District Representatives
Groundwater Management Area-12
Post Oak Savannah GCD
Fayette County GCD
Lost Pines GCD
Mid-East Texas GCD
Brazos Valley GCD

Re: Impacts of Groundwater Pumping on the Colorado River

Figure 1: Figure 6 from Rice Report

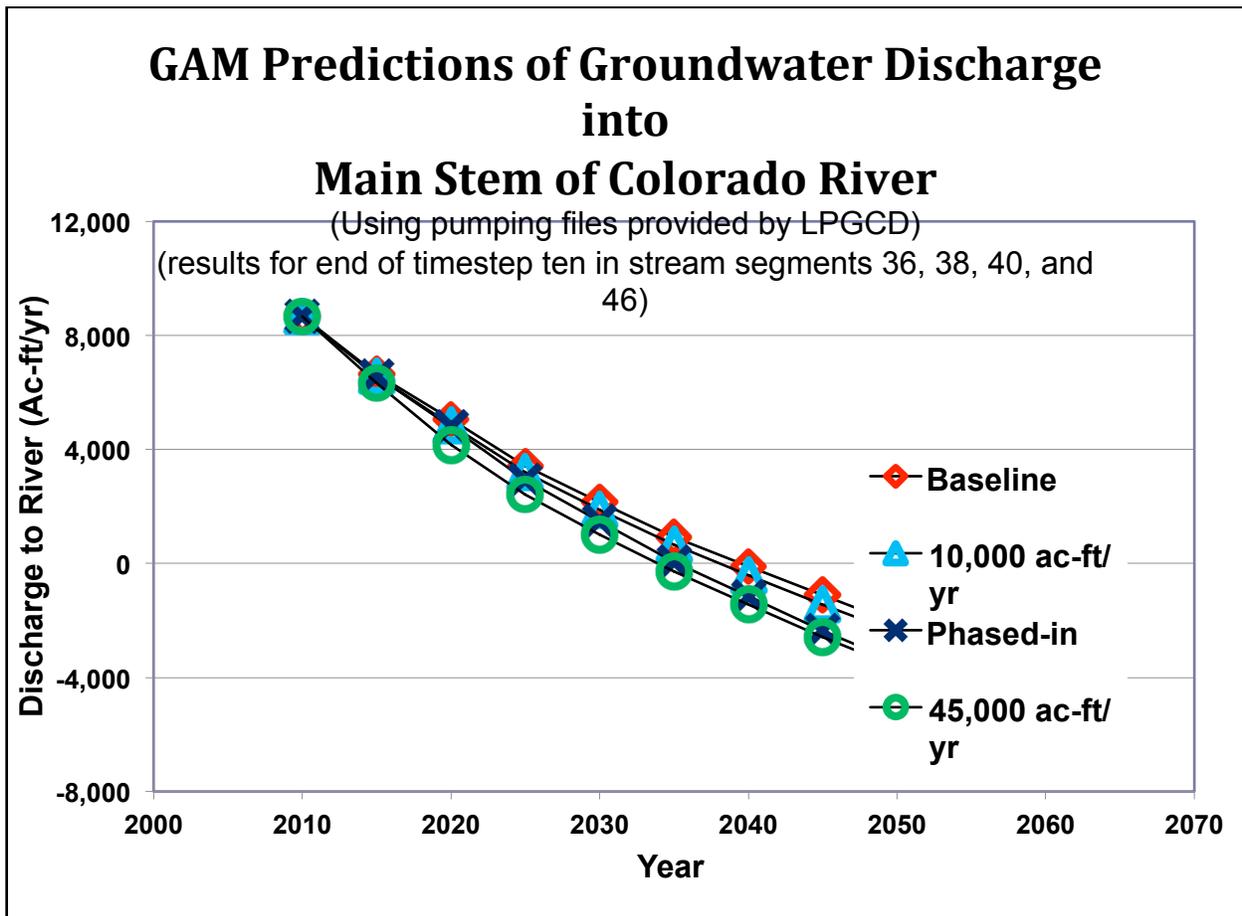
1.2 Impact on the Main Stem of the Colorado River – Rice concludes in Figure 6 of his report that "Proposed phased-in pumping will decrease groundwater discharge to the Colorado River. After about 2040, the predicted effect of the phased-in pumping is little different from pumping at a constant rate of 45,000 acre-feet per year".

Looking at the GAM results, depicted in Figure 6 from the Rice Report, it is clear that the trend is for less water to leave the aquifers each year as outflows to the river, thus the flow in the river each year will contain less groundwater contribution as high rates of pumping continue. It is also clear that this trend reduces outflow to the river as time passes and permitted pumping increases. The extremely negative slope of these trend lines signals a serious impact on outflows to the river over time. ES has concentrated its focus on the Colorado River, however, a clear inference from Rice’s findings is that the same trends would be observed in the Brazos River watershed and in other surface features between the Colorado River and the proposed well field.

Figure 2: Colorado River at Bastrop Gage.
USGS Hydrograph of Flow Rates (cfs), January 1 – December 13, 2013.

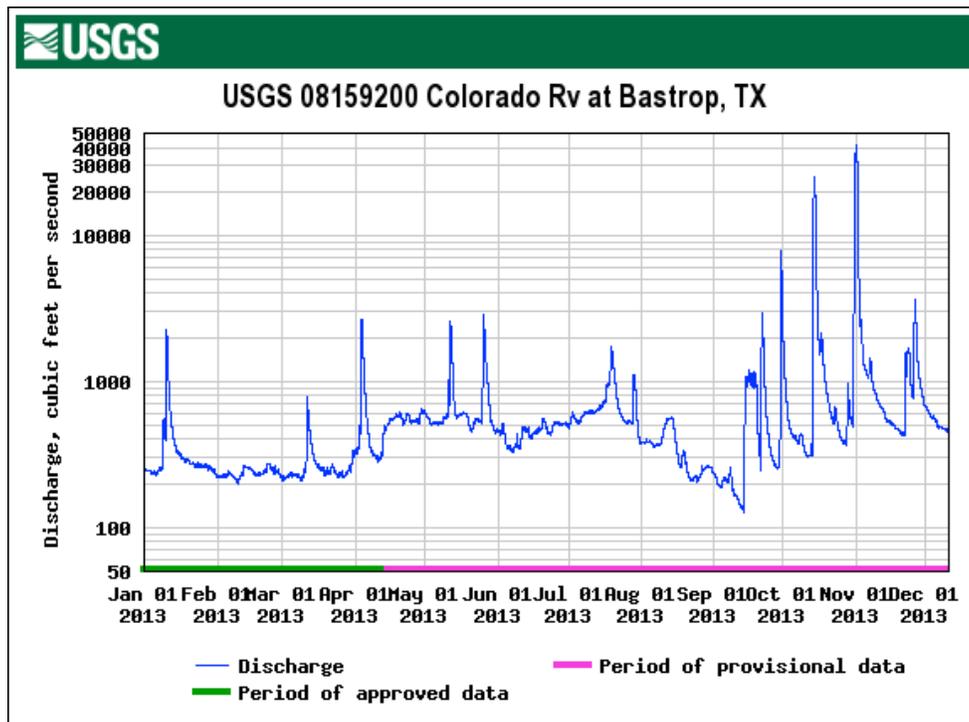
Bastrop Gage¹² (Figure): on September 14, 2013 at 6:11 am the flow of the Colorado River at the Bastrop Gage reached a record low for the year 2013 of 144 cubic feet per second¹³. The standing record low flow for recent years is 143 cubic feet per second set on November 21, 2008, at 3:14 am.

The TCEQ¹⁴ has established environmental flow requirements for the Colorado River at Bastrop Gage during periods of drought to be 120 cubic feet per second. Measured groundwater discharge to the Colorado River ranges from 30-50¹⁵ cubic feet per second. In this real scenario, the flow of the Colorado River due to groundwater outflow from the Carrizo-Wilcox and associated aquifers in the Bastrop segment of the river on September 14 was between 21% and 35% of total flow in the river and between 25% and 42% of the TCEQ requirement. **If this trend continues, the contribution of flow to the river during periods of drought will be significantly less over time.**

It is clear that ANY additional pumping that decreases flow of groundwater to the Colorado River further exacerbates an already serious negative trend.
